TECHNICAL NOTE

File Ref: PZ/VL/P21-2319/03TN

Subject: Potters Farm – Deadline 6 Noise

**THEBERTON HOUSE ESTATE, SIZEWELL C – Potters Farm
Construction Noise Assessment**

Figure 5.1: ES Measurement Location MS4

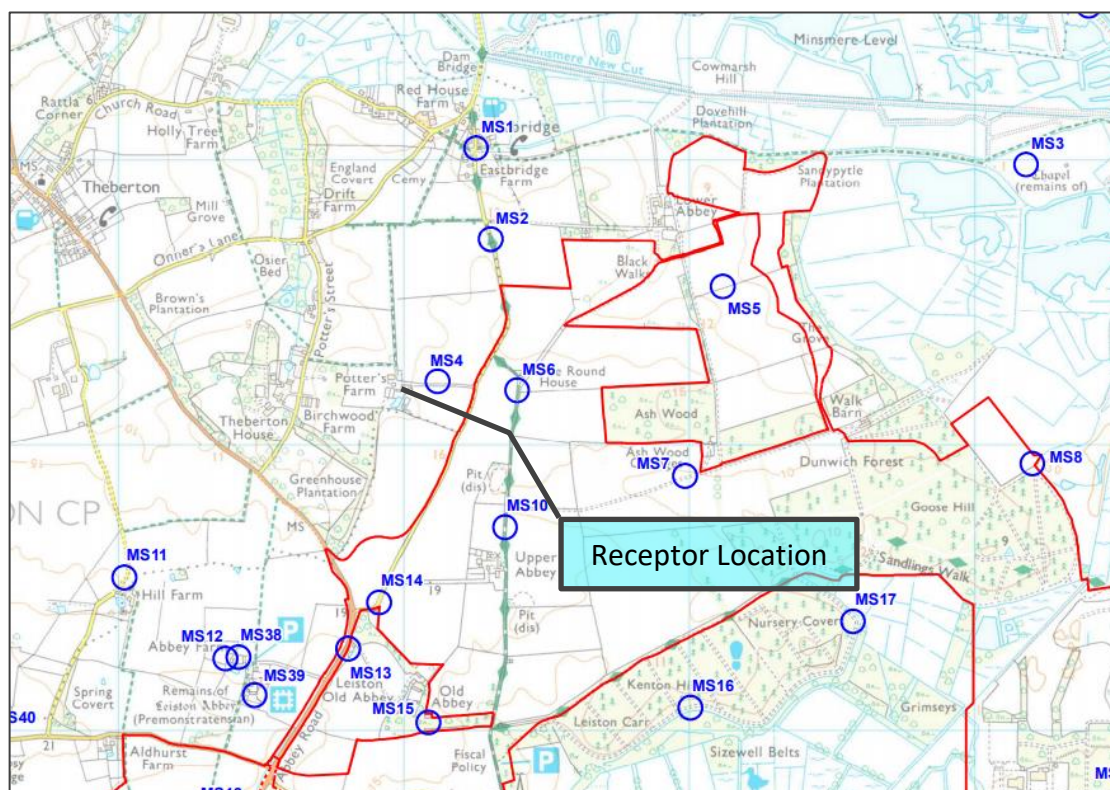
- 5.4 The most representative monitor location in the EDF ES for the Potters Farm Residence NSR would be MS4, which was stated to be a typical measured daytime level of around 43 dB $L_{Aeq,T}$. (Book 6.3, Chapter 11, Construction Noise and Vibration Appendix 11B).
- 5.5 Within the submitted document, the baseline sound levels were largely similar to those from the Create baseline sound monitoring for the daytime ambient sound level, differing by only 2 dB.
- 5.6 The stated measurement duration at MS4 was between the 11th – 14th and 19th – 23rd September 2016 (Page 37, Book 6.3, Volume 2, Chapter 11 Appendix 11A).

Figure 6.1: Phase 1a: No Mitigation *Left* & Phase 1a: With Mitigation *Right*

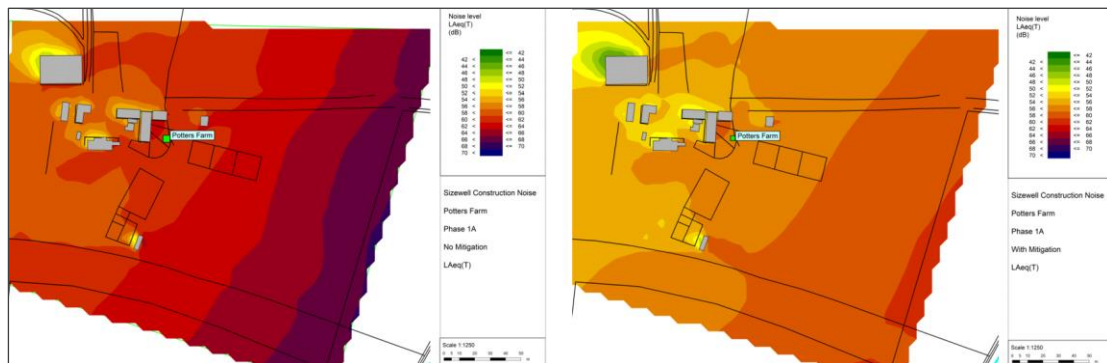
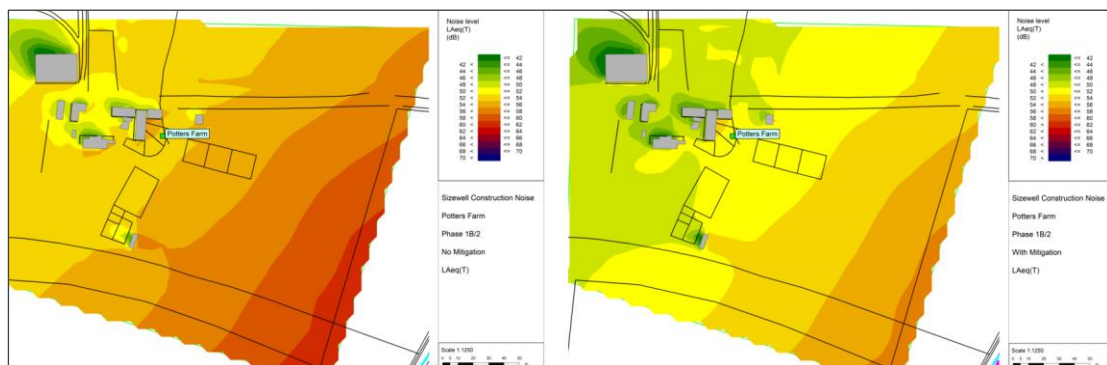
- 6.18 It can be seen in the figures above that in all instances (both with and without mitigation), the predicted ambient would exceed the residual ambient measured. Given the works duration of >4 years, this change would be regarded as considerable.
- 6.19 Table 11.32 in Book 6, Volume 2, Chapter 11 defines the residual effects following mitigation at the various receptors around the site, for which receptor 17 is Potters Farm. The following table shows the assessment of effects following primary, tertiary and additional mitigation measures during the works phases 1a and 1b:

- 6.20 We agree with the classification of a significant effect at the NSR during Phase 1, however it appears that the mineral extraction from the borrow pits has not been considered.

- 6.21 The results and predictions presented in the EDF ES would be considered suitable for the ES stage in the development, however we strongly urge that a more detailed and exhaustive construction noise and vibration assessments should be undertaken once works processes have been finalised. This should include assessment of the efficacy of all additional mitigation measures.
